**METROPOLITAN GOVERNMENT OF NASHVILLE AND DAVIDSON COUNTY**

**STAFF RECOMMENDATION**  
**1820 Wildwood Avenue**  
**November 14, 2012**

**Application:** New construction-addition  
**District:** Belmont-Hillsboro Neighborhood Conservation Zoning Overlay  
**Council District:** 18  
**Map and Parcel Number:** 11704013500  
**Applicant:** Manuel Zeitlin, architect  
**Project Lead:** Robin Zeigler, robin.zeigler@nashville.gov

<p><b>Description of Project:</b> Proposal is to construct a two-story addition with attached garage and carport to a one-story contributing building.</p> <p><b>Recommendation Summary:</b> Staff recommends approval with the conditions that</p> <ul style="list-style-type: none"><li>• the applicant obtain final approval of specifications for windows and doors and roof color from staff ;</li><li>• if new locations for mechanicals are necessary, the new location be approved by staff;</li><li>• the eave of the first portion of the right-side addition is brought down to be more in keeping with the home's existing roofline; and</li><li>• windows or some other architectural feature be employed to break up the long solid wall portion of the right rear side.</li></ul>

1820 WILDWOOD  
W, N ELEVATIONS  
REVIEW SET  
10-31-12

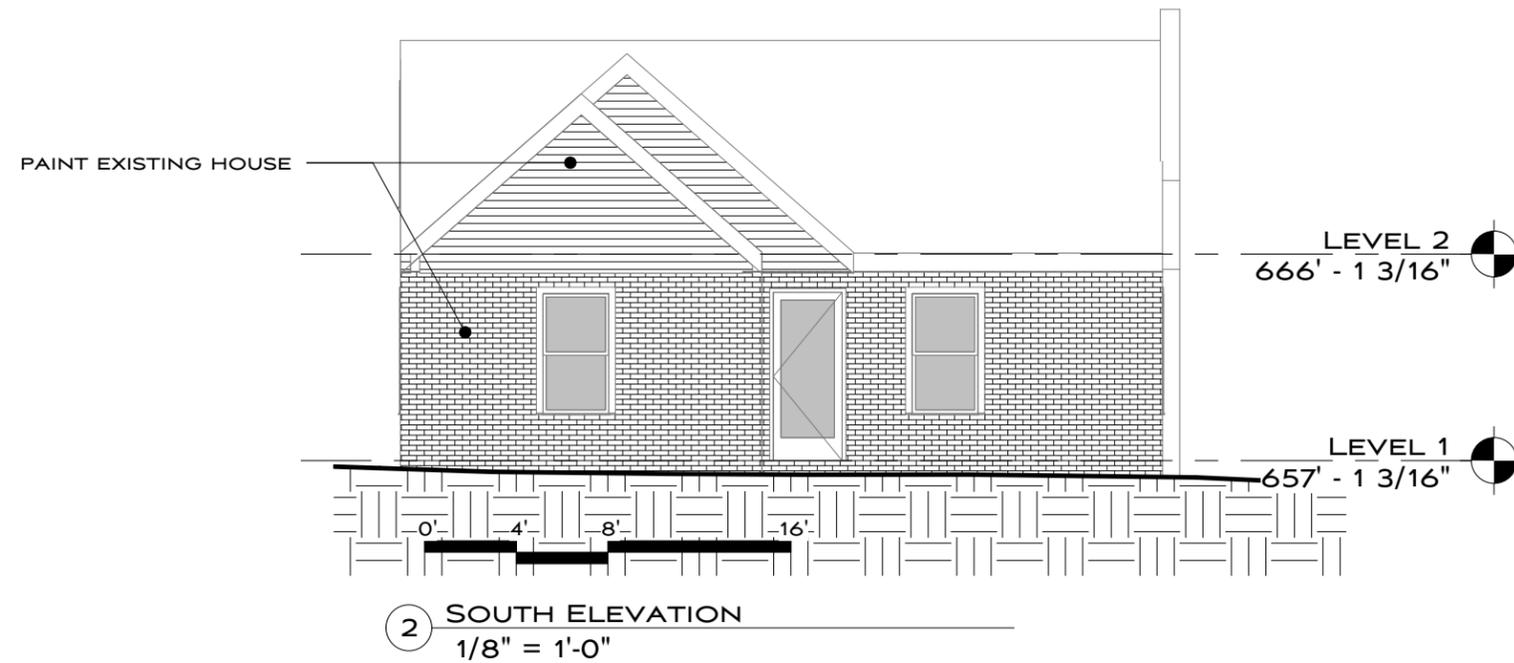
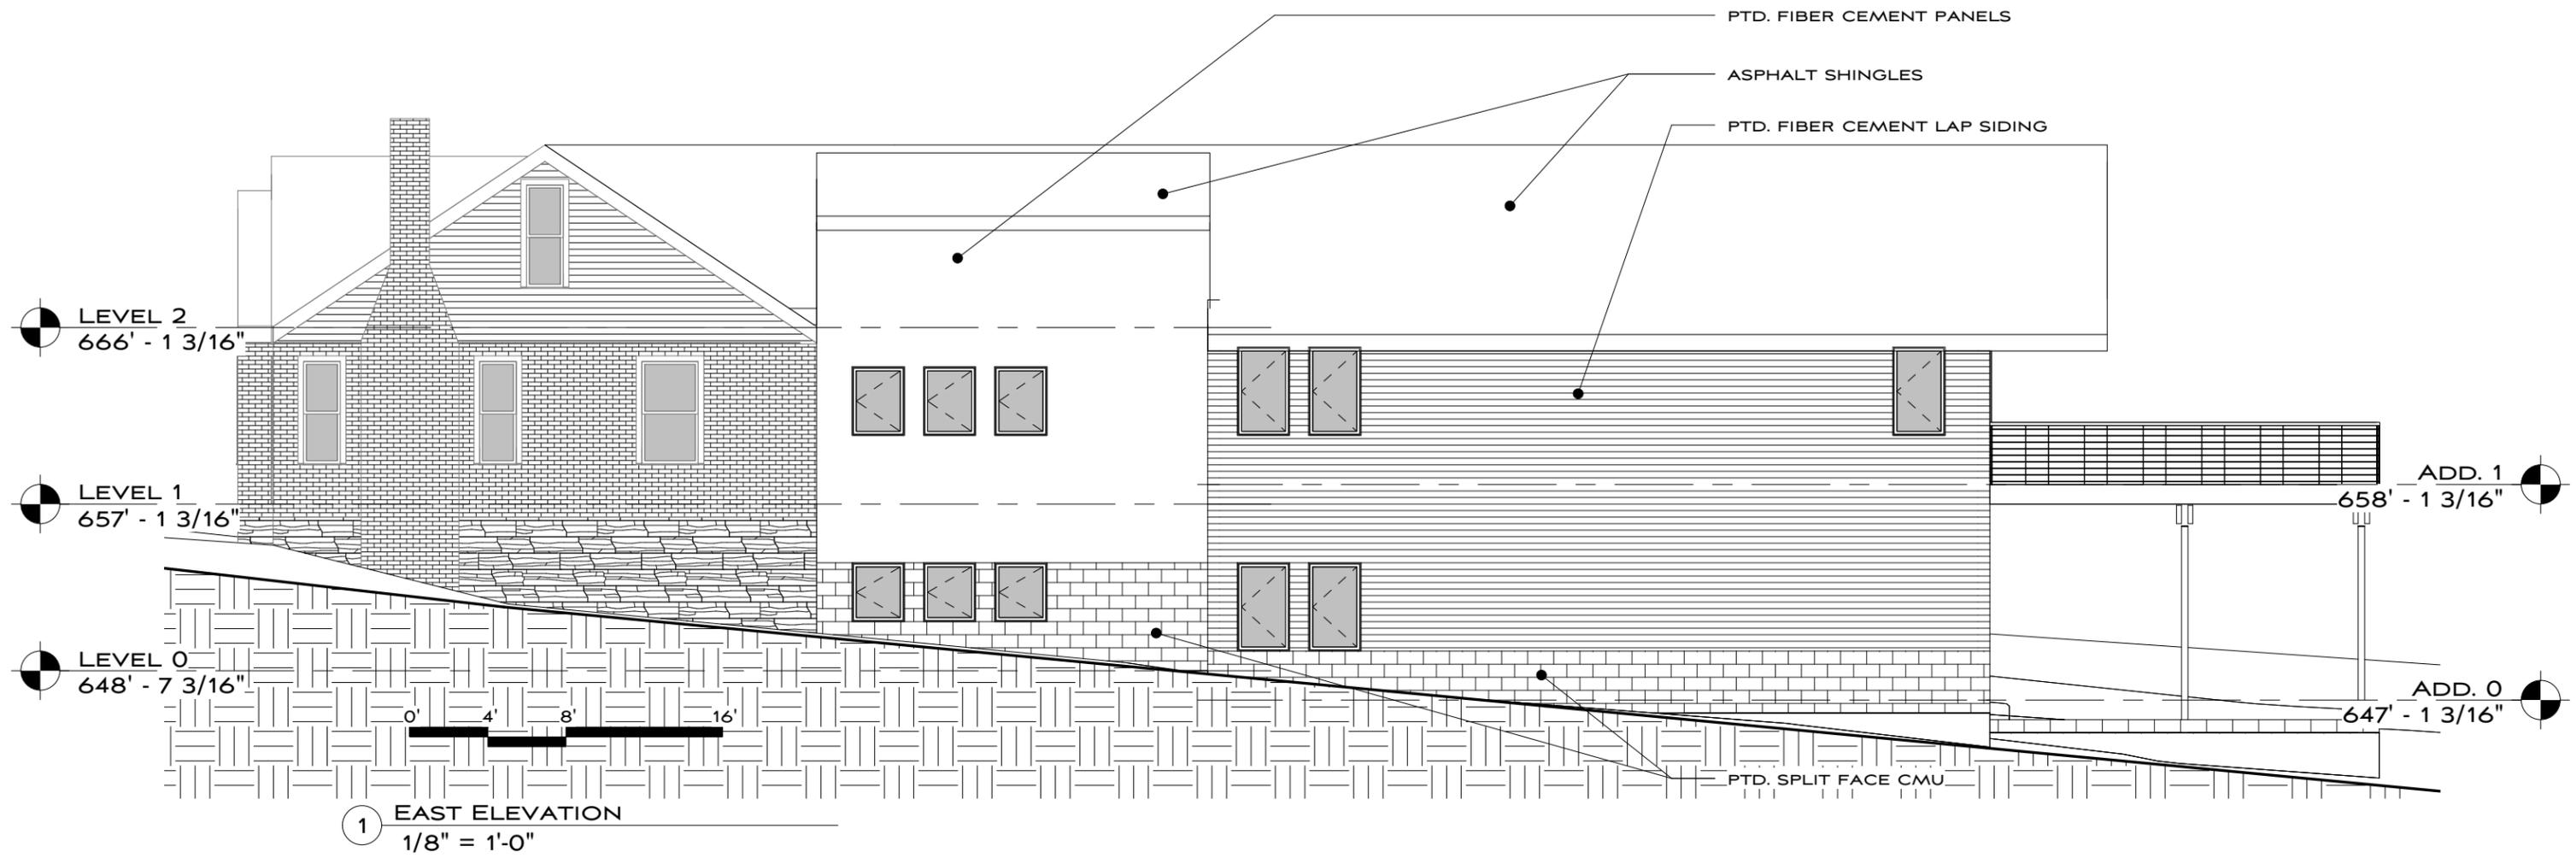
**Proportion and Rhythm of Openings:** The dimension of window openings varies but maintains a proportion of twice as tall as they are wide for primary windows and maintains a rhythm consistent with the existing house with the exception of the rear right side. This side should be broken up with windows or other architectural elements such as a bay. The applicant has agreed to this condition but revised drawings are needed. The project meets section II.B.g of the design guidelines.

- the applicant obtain final approval of specifications for windows and doors and roof color from staff ;
- if new locations for mechanicals are necessary, the new location be approved by staff;
- the eave of the first portion of the right-side addition is brought down to be more in keeping with the home's existing roofline; and
- windows or some other architectural feature be employed to break up the long solid wall portion of the right rear side.
